**SUBJECT: Duke Power Company LLC d/b/a Duke Energy Carolinas, LLC
(Duke)
McGuire Nuclear Station, Units 1 & 2
Docket Numbers 50-369 and 50-370
Catawba Nuclear Station, Units 1 & 2
Docket Numbers 50-413 and 50-414
Relief Request 06-GO-001 Request for Additional Information**

On August 30, 2006, the NRC Staff electronically requested additional information regarding several issues contained within the relief request. The Duke response is attached.

Figure 1 Residual Stress Distribution from White Paper (see Text)

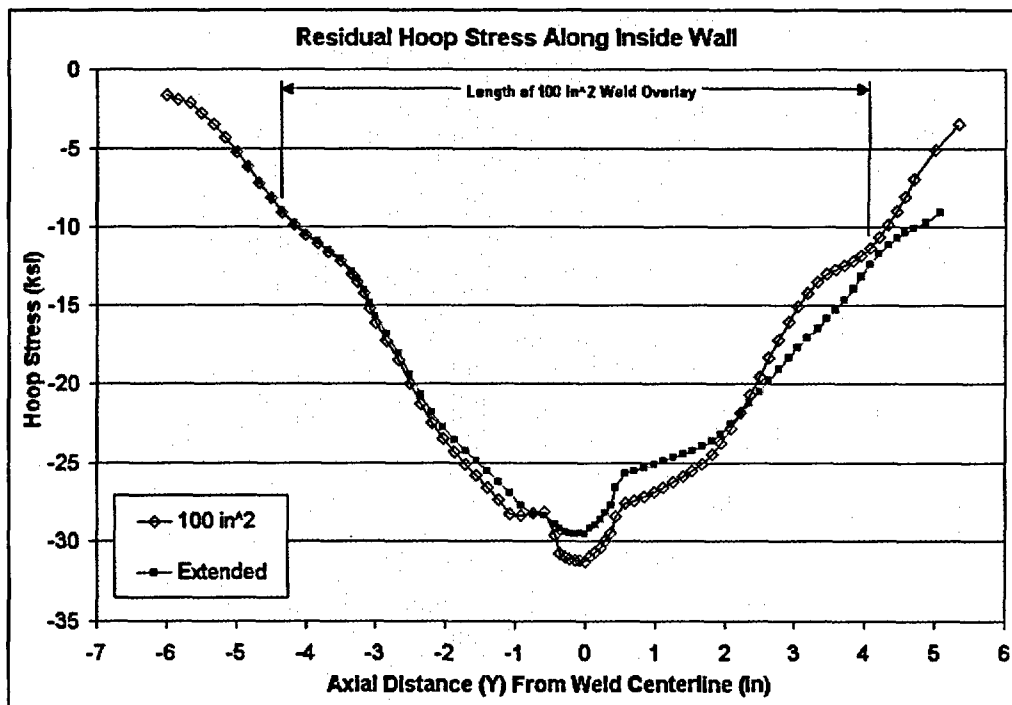
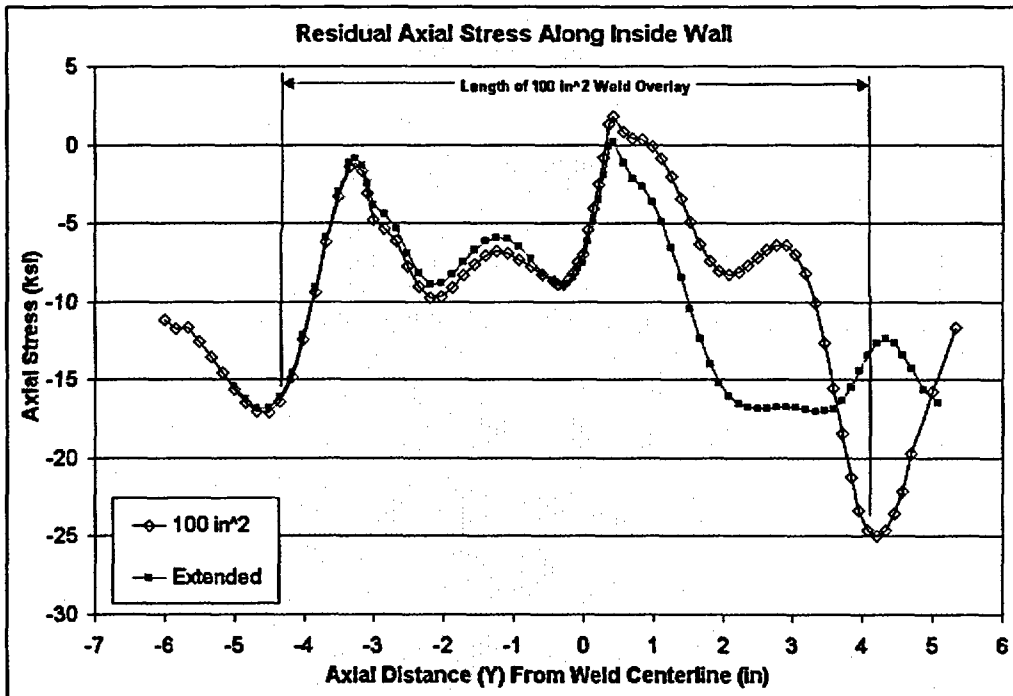
7. The submittal indicates that the weld surface areas over ferritic material for the subject weld overlays are expected to be approximately 120 square inches for the surge line nozzles. Provide a discussion on how the information in the white paper referenced in your submittal directly applies to the configuration of the surge line nozzles and supports your request to exceed the current 100 sq in limitation in Code Case N-638-1. Also discuss operational experience at other nuclear power plants with weld overlays that exceed 100 sq in. Although the submittal references requirements of Code Case N-638-3 as justification for increasing the allowable overlay surface area, the staff notes that Code Case N-638-3 has not been endorsed by the NRC.

(a) Residual Stresses – Using as an example a BWR Feedwater Nozzle, the white paper cites EPRI sponsored analyses [1] of an overlay that just equaled 100 in² coverage over the ferritic steel base metal. Two axisymmetric finite element models were created, one with the 100 in² weld overlay and the other with the weld overlay extended on the nozzle side until it blended into the nozzle taper surface (approximately 126 in²). Figure 1 shows the post overlay residual stress on the nozzle inside surface for both models. It is seen that the extended overlay configuration did not significantly alter the residual stress results, and if anything, made the axial stresses even more compressive.
